Re: *Addendum No. 2*
Jefferson Booster Station Replacement
Ashtabula County Board of Commissioners, OH

Date: July 23, 2026

ASHTABULA COUNTY	JEFFERSON, OHIO
JEFFERSON BOOSTER STATION REPLACEMENT	ASHTABULA COUNTY
ELECTRICAL - 10 SERIES	ELECTRICAL- PLAN, NOTES, & 1-LINE

PROJECT NO.	232225
DISCIPLINE	ELECTRICAL
SHEET NAME	10E-01
SHEET	OF
14	17

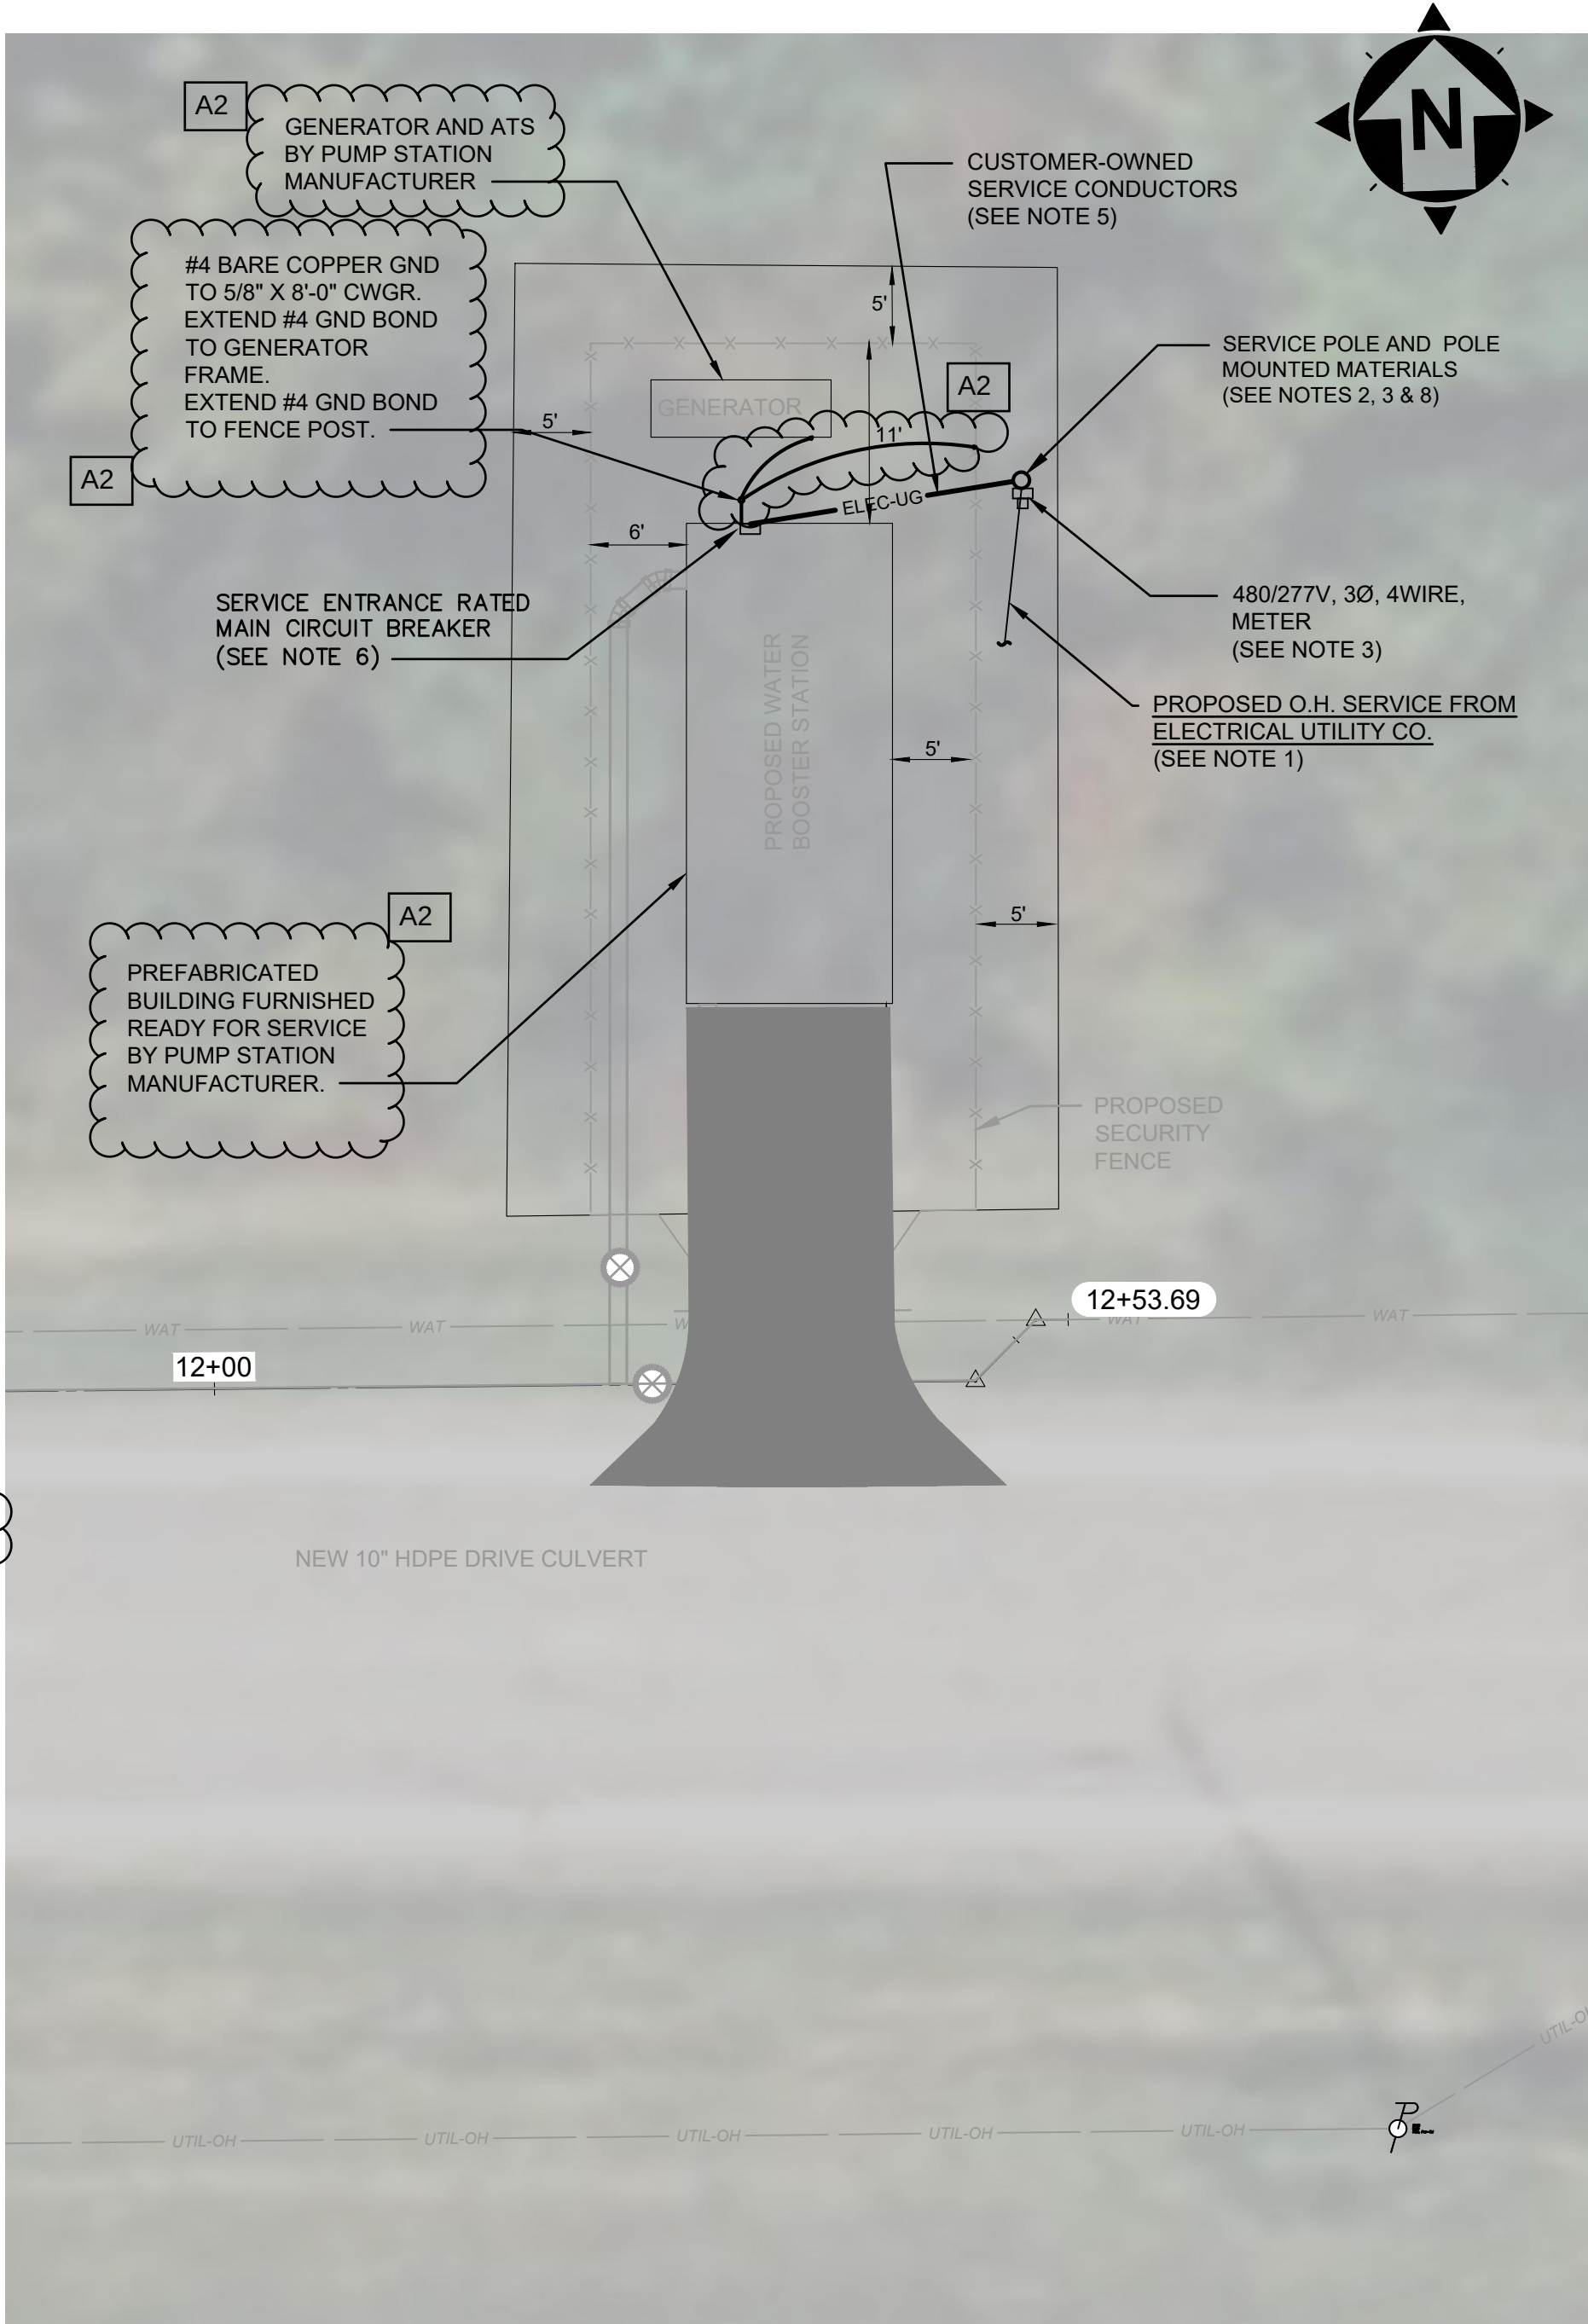
Q4. Will the electrician be providing a new disconnect?

A4. Contractor to coordinate size required by the station manufacturer. A new disconnect is required prior to the meter box, as required by the electrical utility. A main disconnect shall be provided within the booster station.

FROST PROOF SLAB DETAIL
NOT TO SCALE

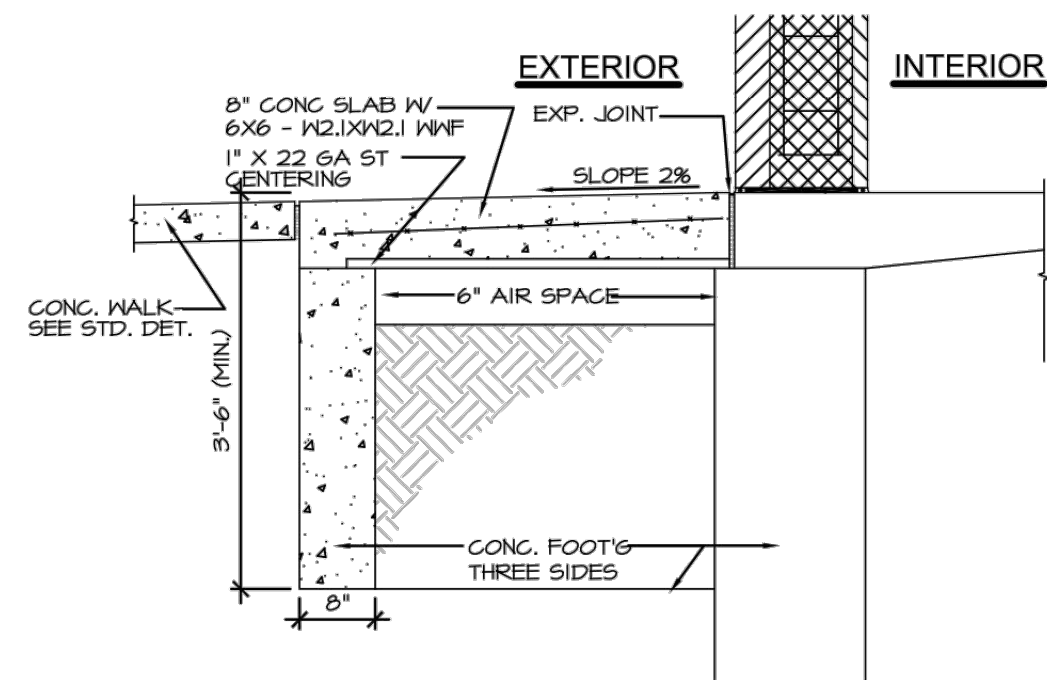
Q7. A frost proof slab is required for the building permit, can you provide dimensions?

A7. See detail on sheet 15 of 17, the slab shall extend 4' off the building and extend 1' from the entrance on either side, or as required by building code. The cost of the frost proof slab should be included in the asphalt pavement.

GENERATOR PAD DETAIL
NOT TO SCALE

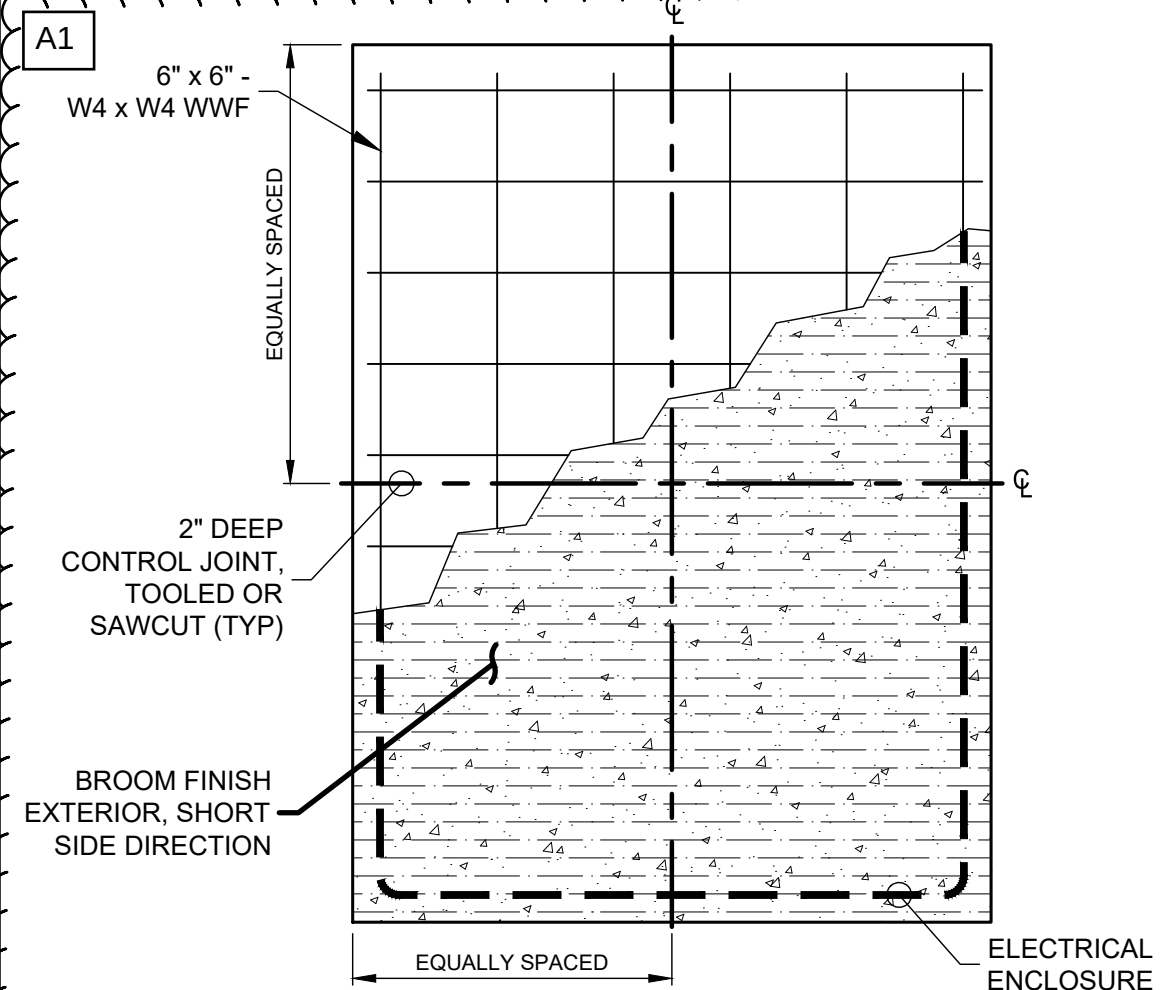
Q6. Can you provide a size for the generator pad and building foundation?

A6. The station manufacturer is to provide the size for the building foundation and generator pad. Contractor shall coordinate with station manufacturer for generator pad size and building foundation. Refer to details on plan sheet 12 of 17 for minimum dimension requirements.
